**APPLICATION FOR
URBAN DESIGN COMMISSION
REVIEW AND APPROVAL**

PROJECT ADDRESS: PHASE I- 800 North Block, East Washington Avenue (802, 854; Block 143)

Galaxie Phase I

Design Progression Items:

Livingston Tree Plan Changes
10/16/2014

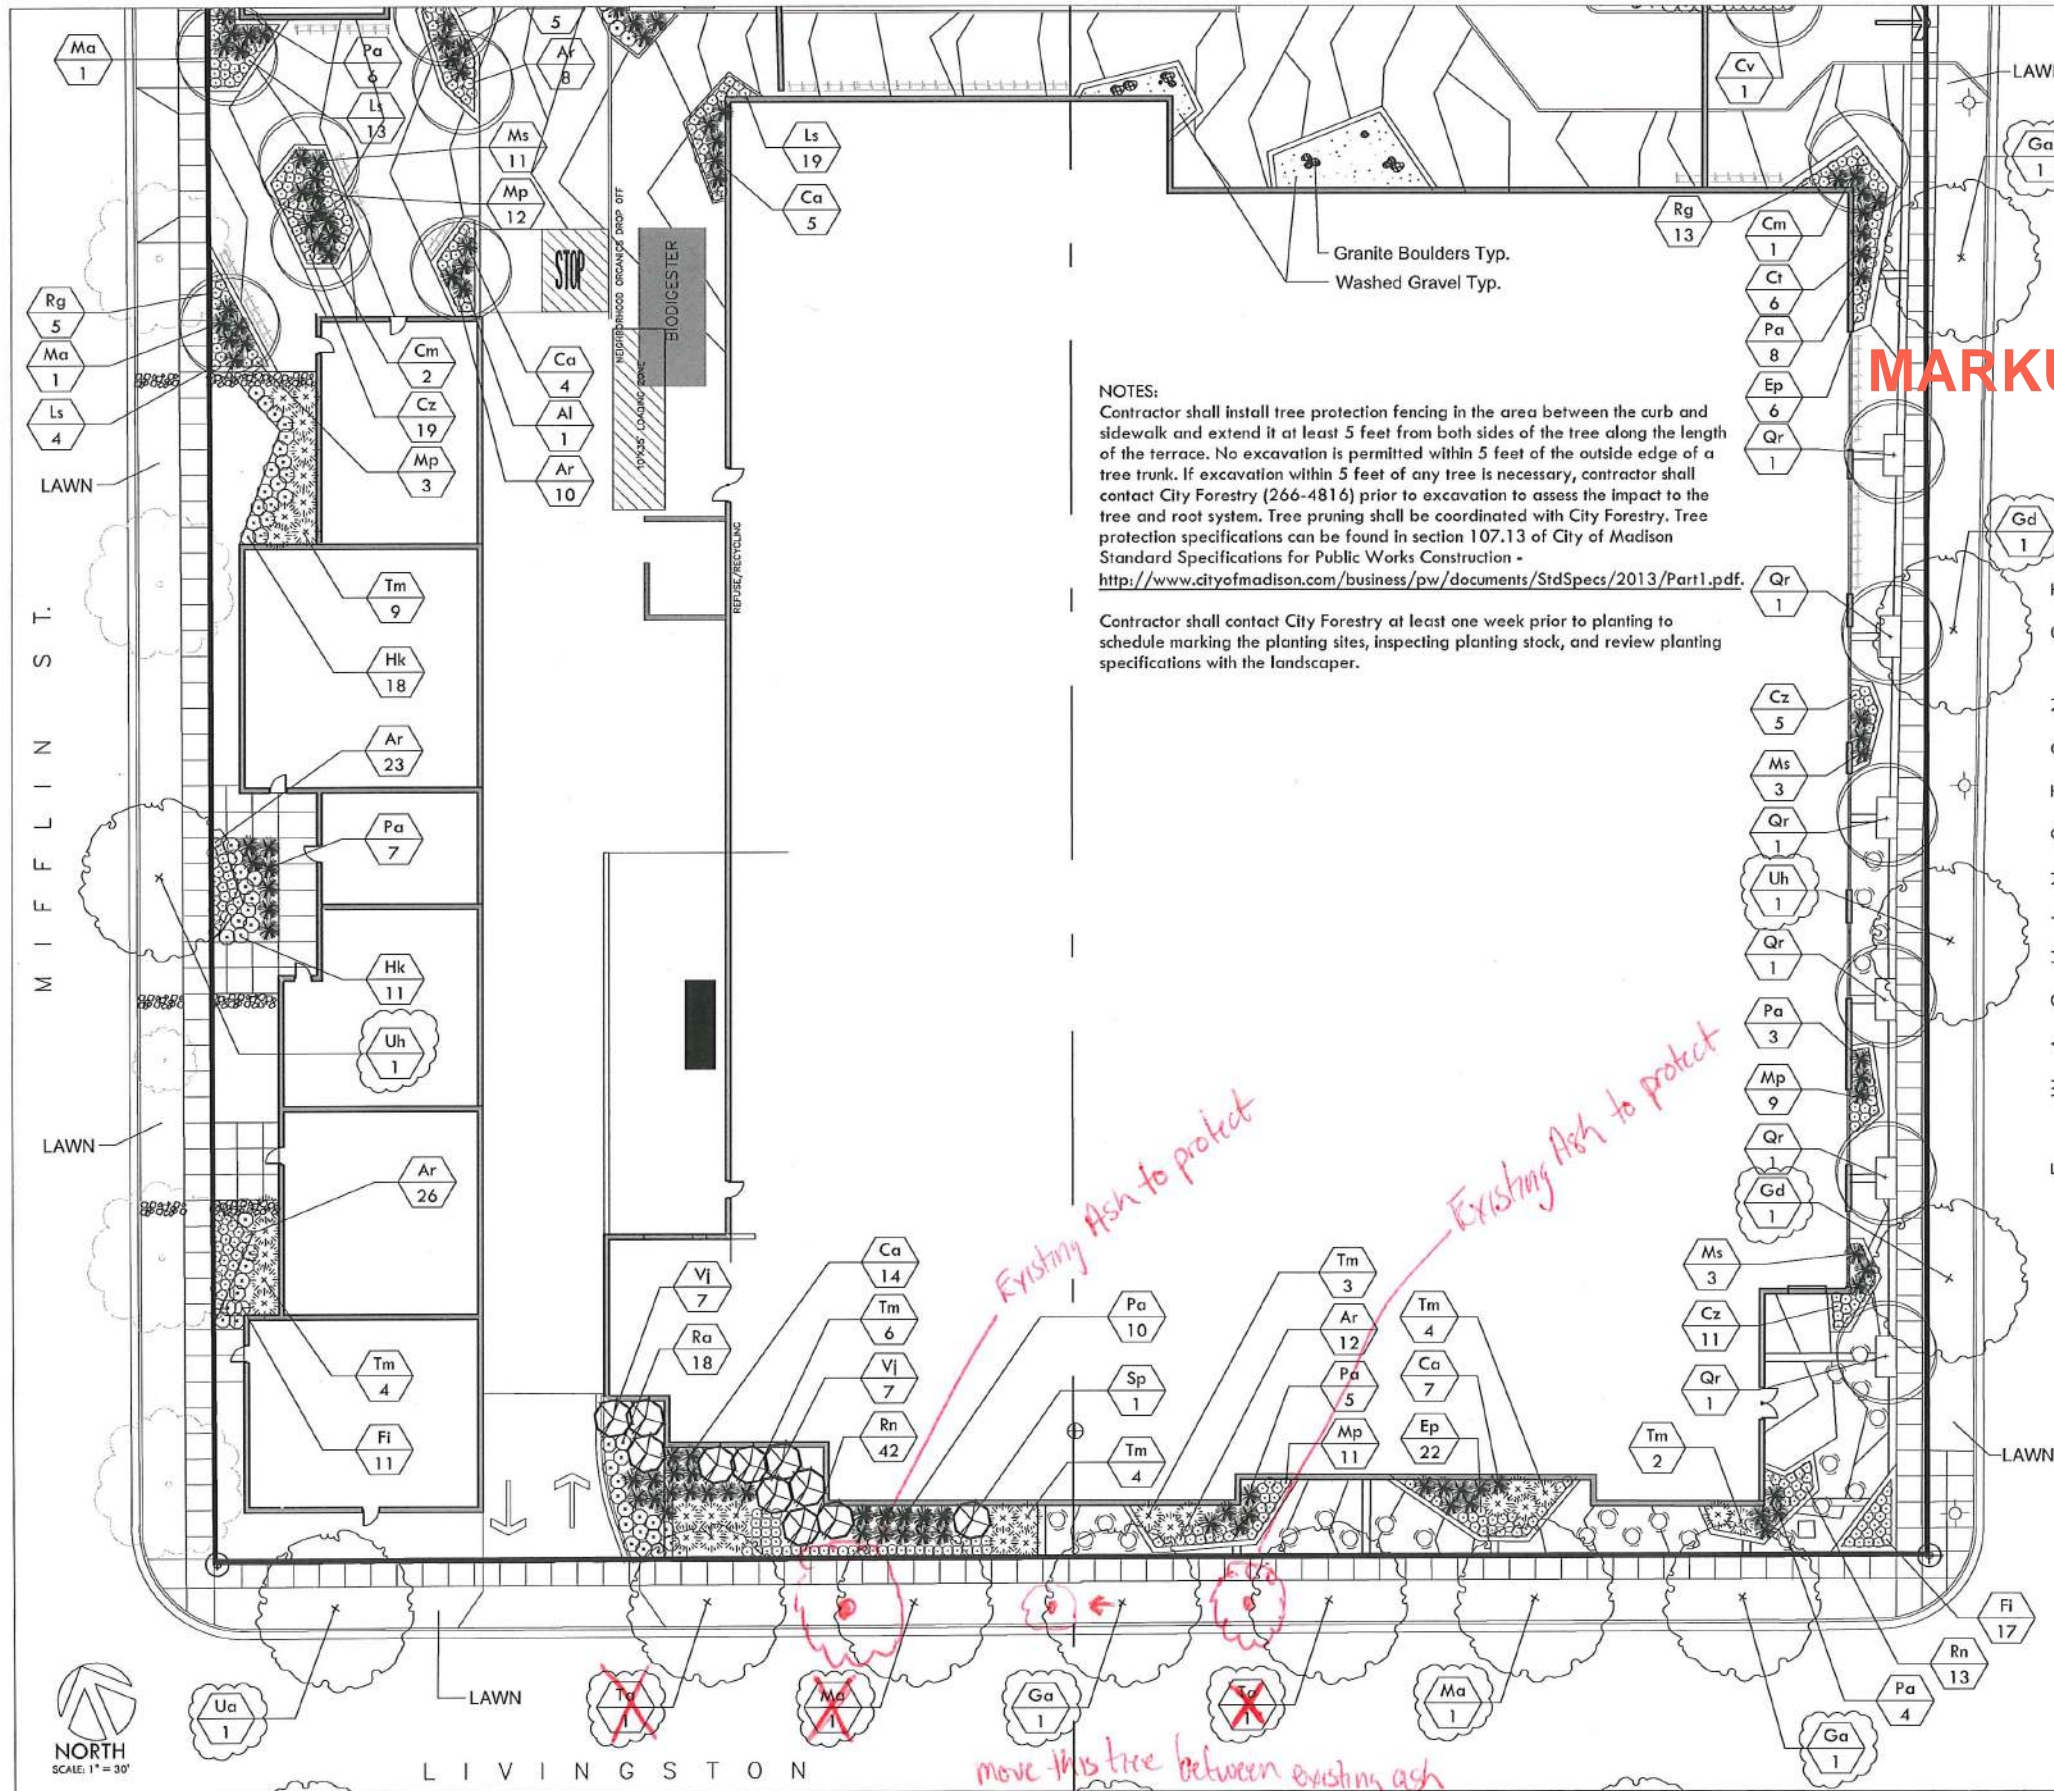
- 10: Location of vents for Grocery Store
Reason: Mechanicals were design/build and information was not available at time of approvals
- 11: Tree Modifications on Livingston
Reason: Request by Alder, constituents, and Forestry requested changes to approved Tree Plan email from Dean Kahl: Please see the attached tree planting plan. We'll need to take the two lindens and one of the maples off the planting plan. One of the ginkgos will also need to be located a little bit more towards Mifflin St, so it will be placed between to the two ash that are to be saved. (Also see attached marked up document)

MARKUP FROM DEAN KAHL

CONTROL JOINTS AND TREE ADJUSTMENTS

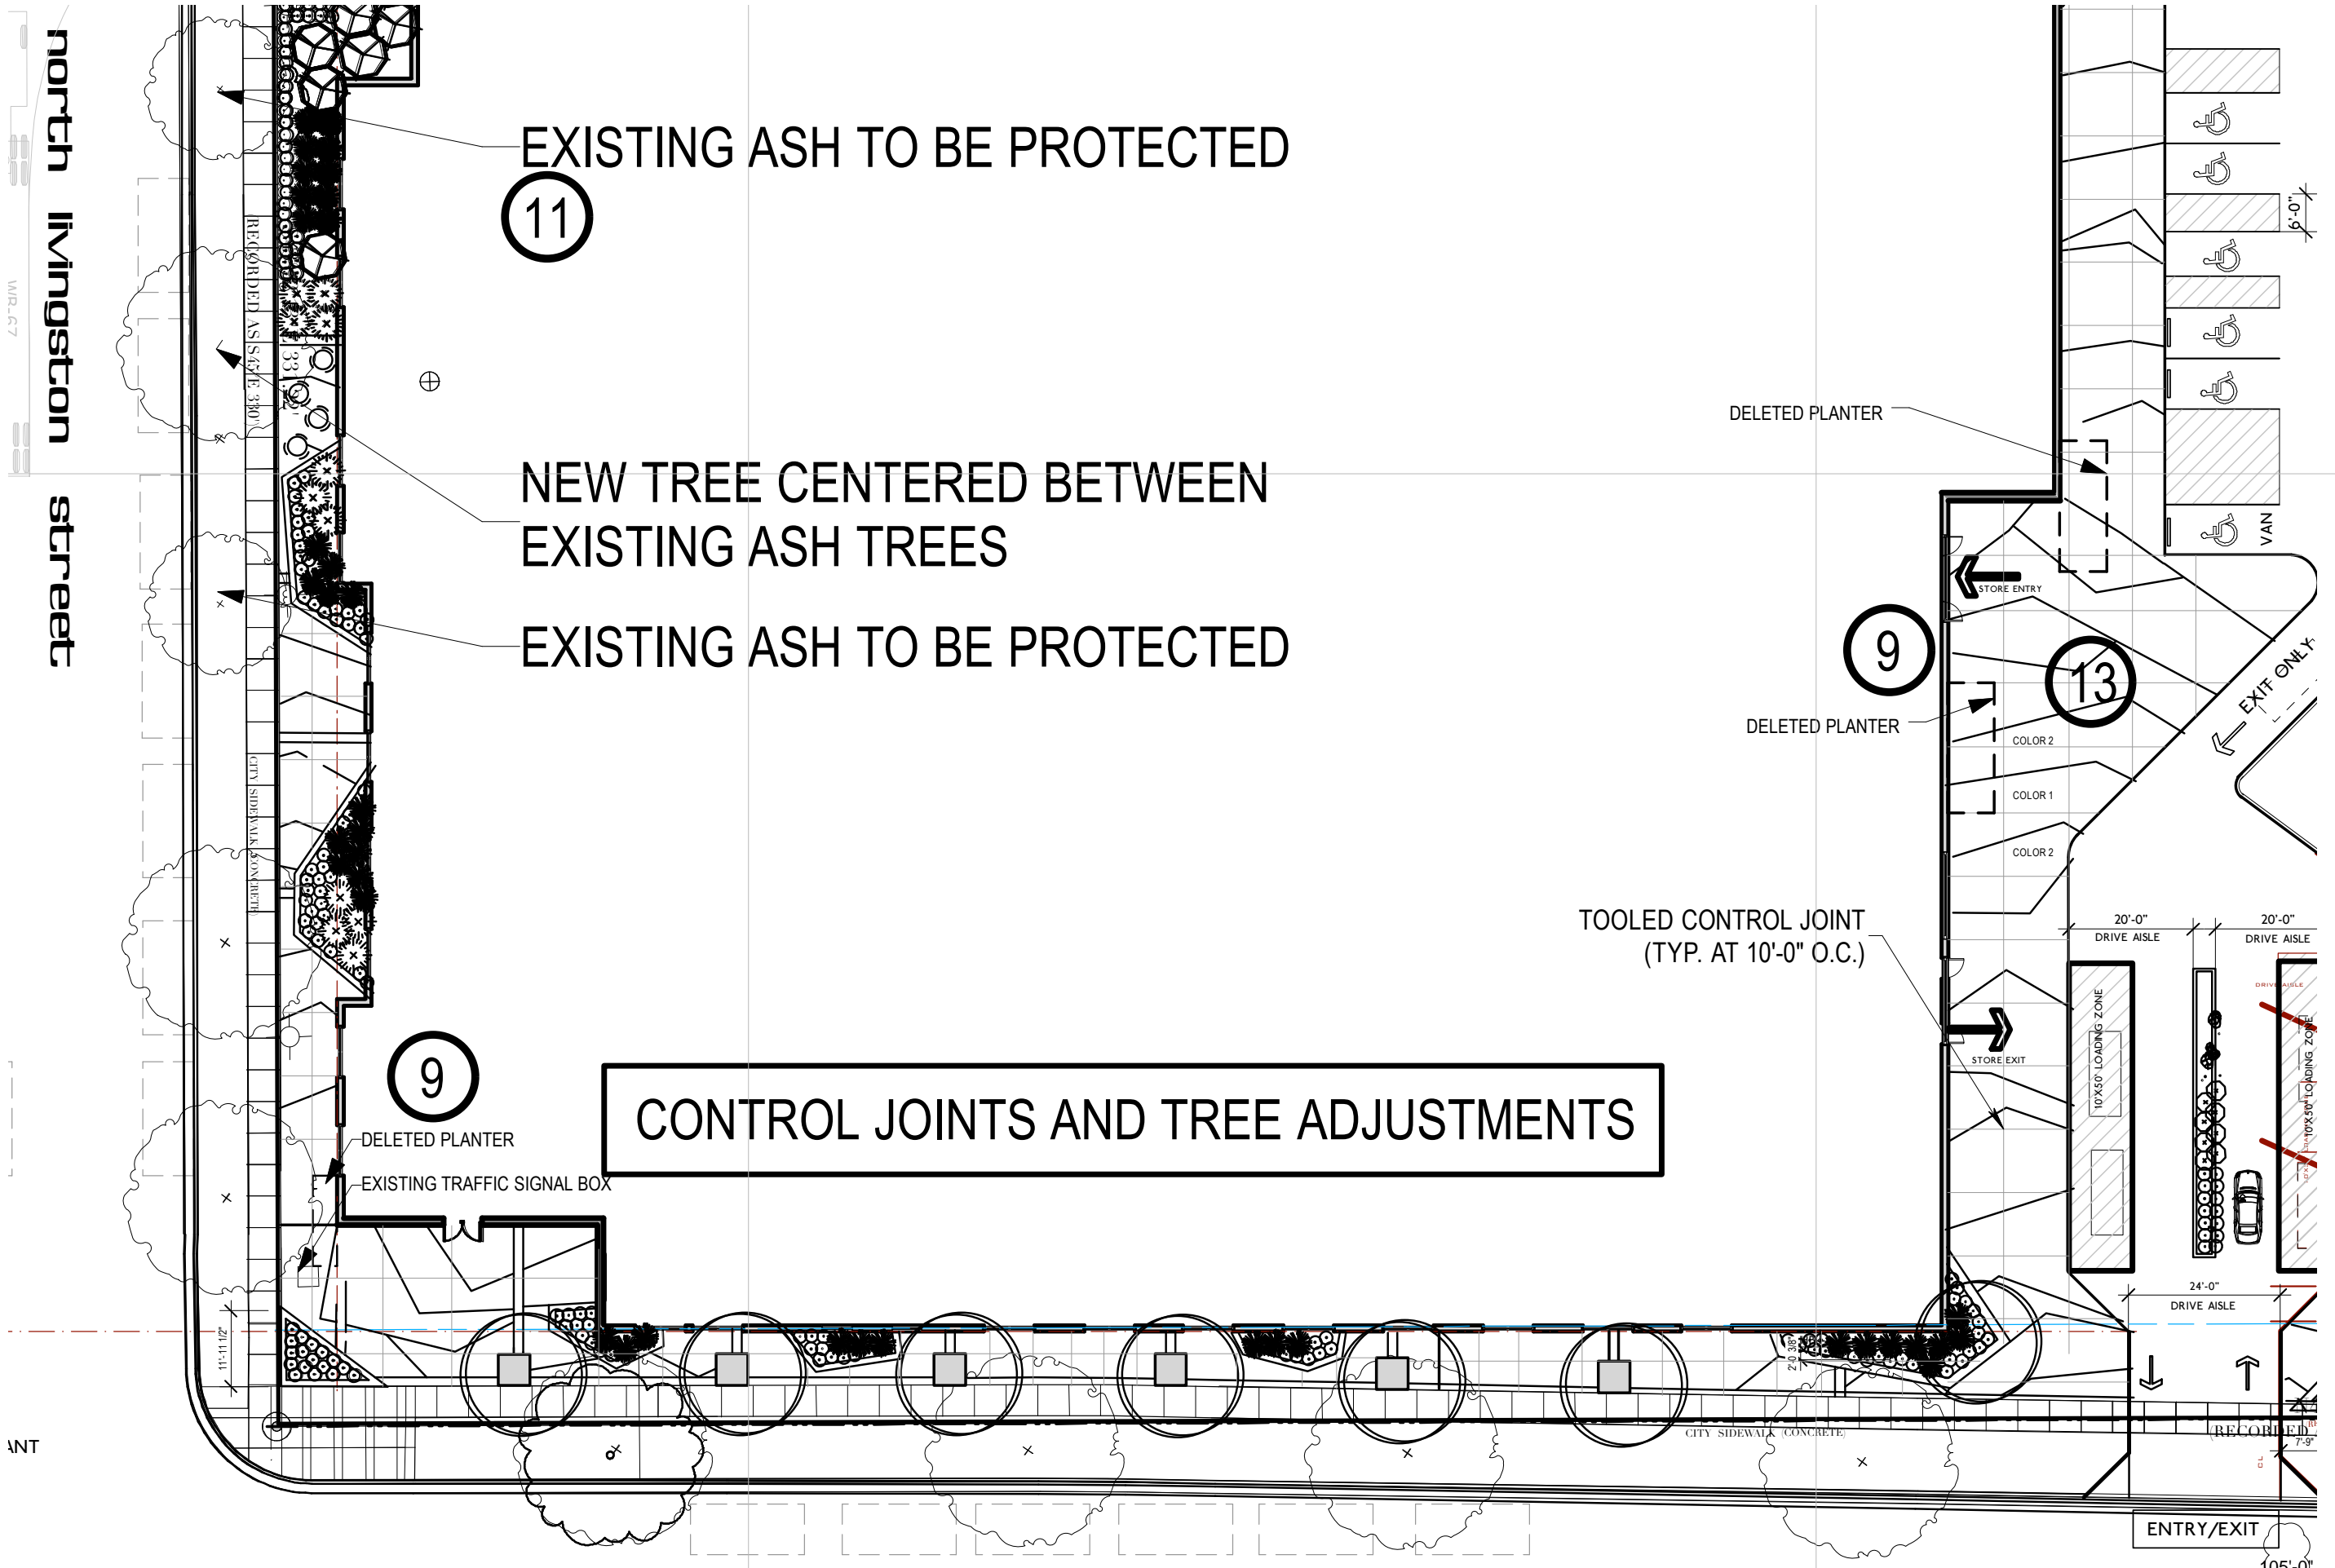
- 9: Deletion of planter at Livingston and East Washington Grocery entry and at Grocery Entry
Reason: Stoplight signal box and planter created a path obstruction. Planter conflicted with main Grocery entry from Parking Structure

- 13: Site concrete control joints
Reason: Clarification of control joint locations at stained concrete

NEW TREE CENTERED BETWEEN EXISTING ASH TREES

DELETED PLANTER

DELETED PLANTER

DELETED PLANTER

TOOLED CONTROL JOINT (TYP. AT 10'-0" O.C.)

EAST WASHINGTON ELEVATION
COMPARISON OVERLAY

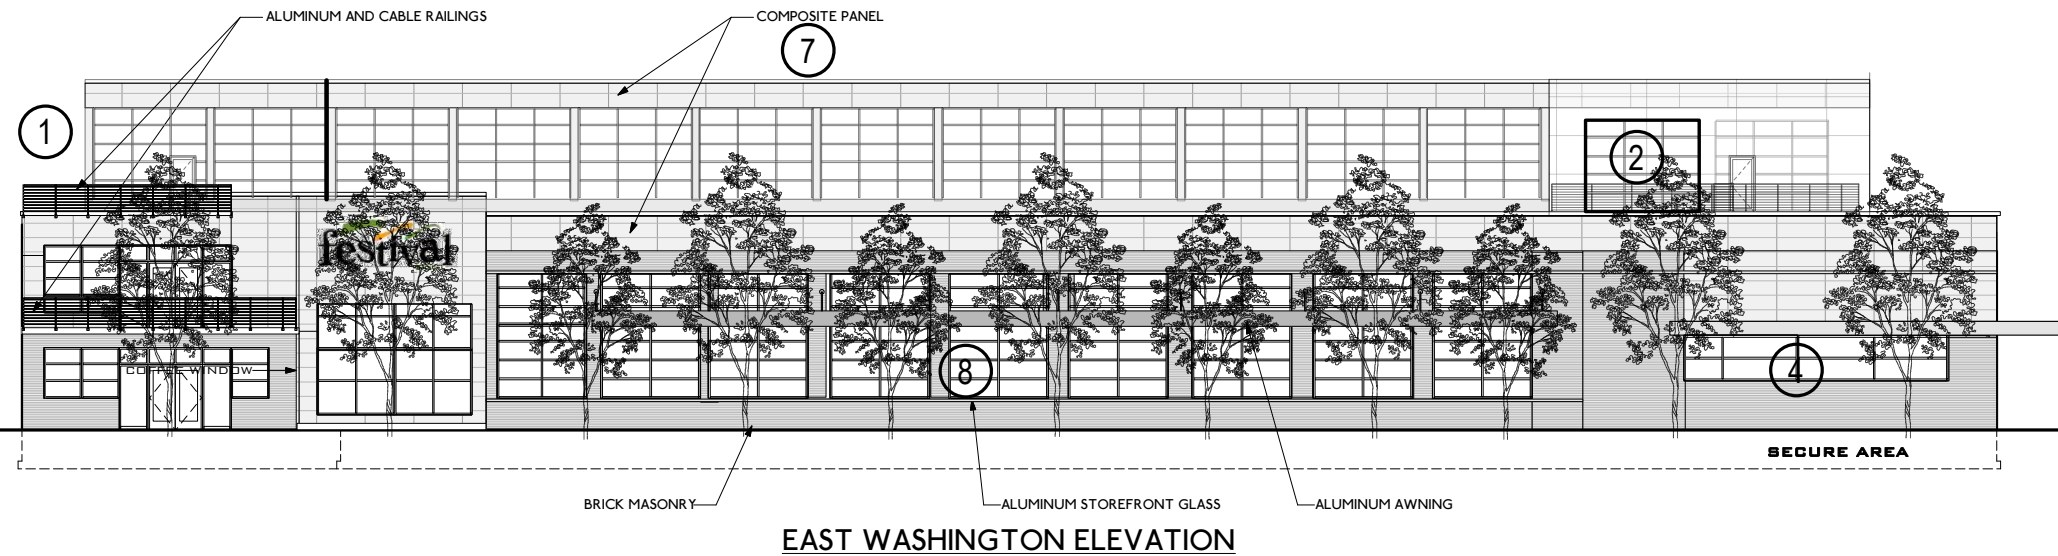
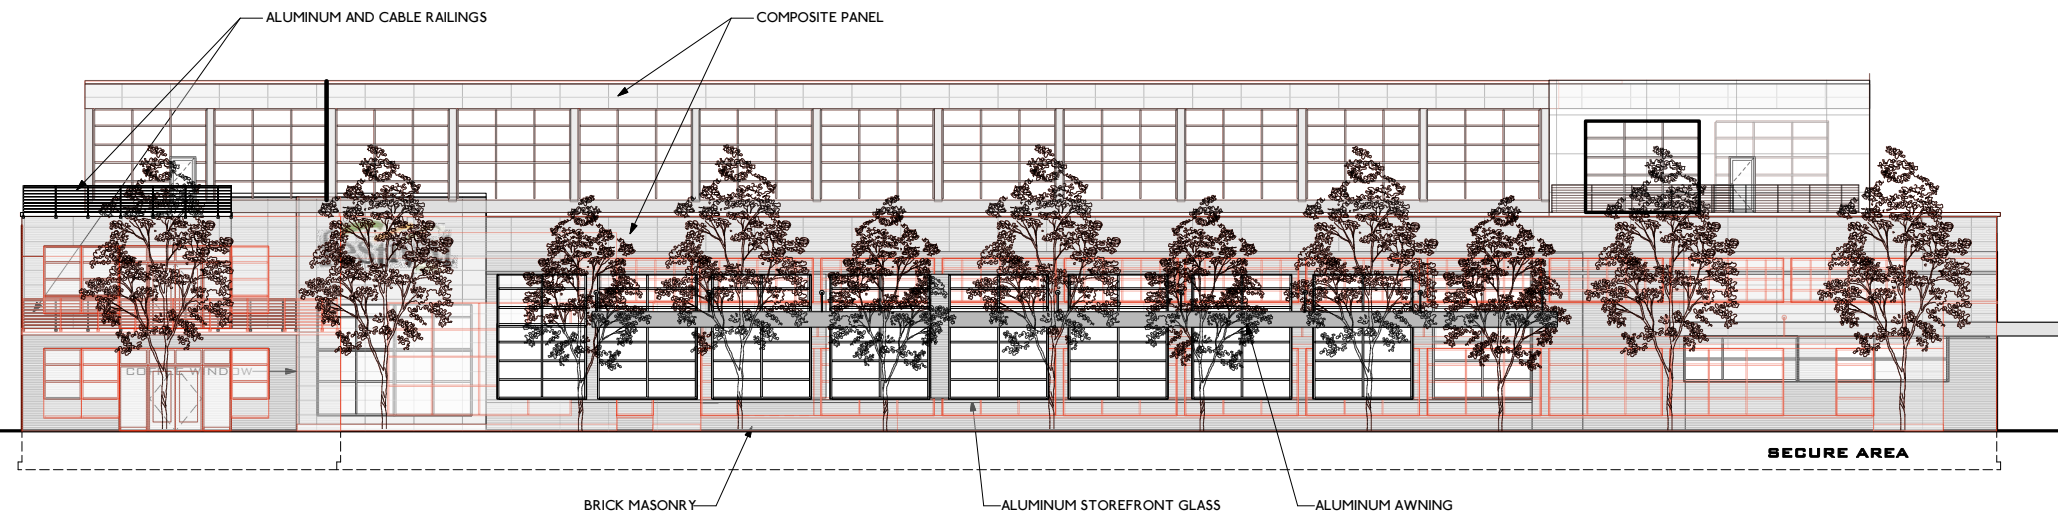
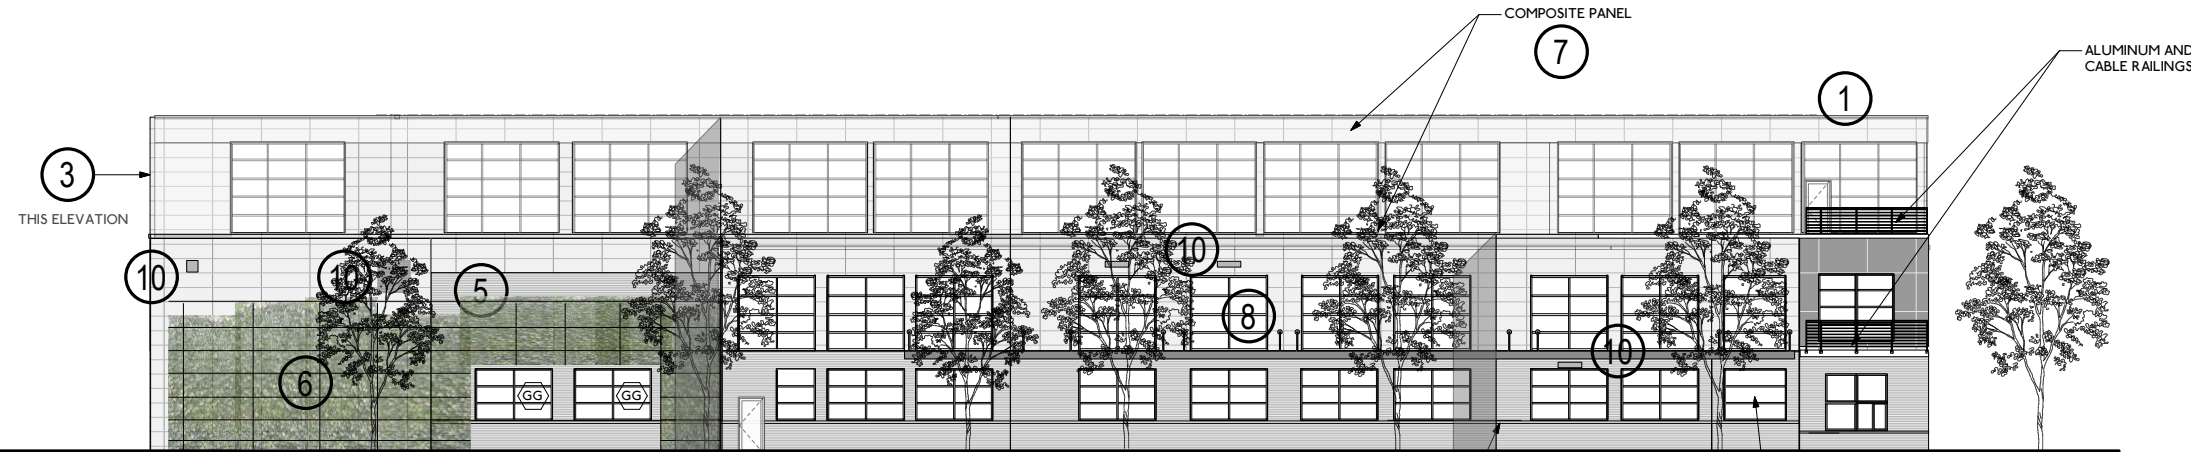
- 1: Install (2) exterior doors and railing at 3rd floor commercial roof area at Livingston and East Washington to create a tenant exterior balcony.
Reason: Owner and Tenant request

- 2: Install additional windows along East Washington at second floor at approved tenant exterior balcony.
Reason: Owner request
- 3: Install additional windows at E. Mifflin elevation
Reason: Tenant request

- 4: Reconfigure narrow Windows at East Washington entry
Reason: Anchor Tenant request
- 5: Delete Window at N. Livingston
Reason: Anchor Tenant request
- 6: Add Landscape trellis along N. Livingston
Reason: Roof Farm request

- 7: Substitute Composite panel
Reason: Architect request- supplier and installer deficiencies for previously sourced product
- 8: Minor window spacing changes
Reason: Several: Implementation of Whole trees for Grocery framing necessitated additional structural elements; program functions of grocery store, fewer obstructions of East Washington primary windows; structural components of Grocery mezzanine at Livingston
